1.1 Company		STMicroelectronics International N.V
1.2 PCI No.		ADG/22/13201
1.3 Title of PCI		IPM SLLIMM 2nd series Full molded (FM) frame standardization
1.4 Product Category		IPM
1.5 Issue date		2022-01-04

IPM SLLIMM 2nd series Full molded (FM) frame standardization

INVOLVED PRODUCTS: IPM SLLIMM 2nd series Full molded (FM) – standard part numbers

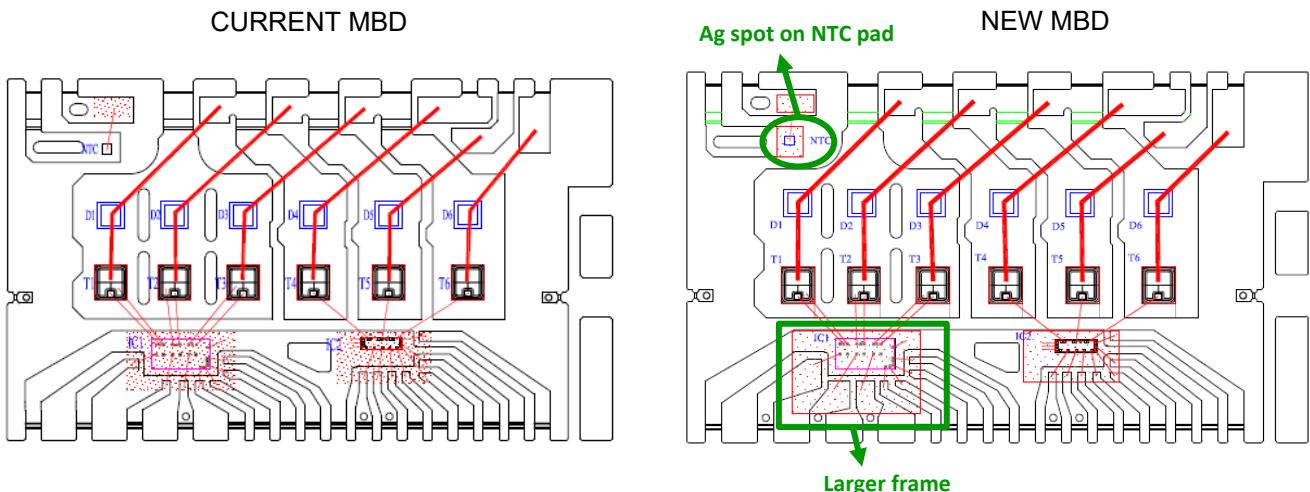
Standard part numbers (STGIFxxx-L/-X) will use same frame of enhanced ones with TVS inside for ESD robustness improvement (STGIFxxx-LZ/-XZ). New frame has larger pad on Vboot pins to allocate the TVS devices.

Moreover, an Ag spot will be added on NTC pad (where available) for reliability improvement.

Here below you can see a comparison picture between current and new Mounting Bond Diagram (MBD):

From a performance point of view, we can guarantee there are neither electrical nor thermal difference moving from current MBD to new one.
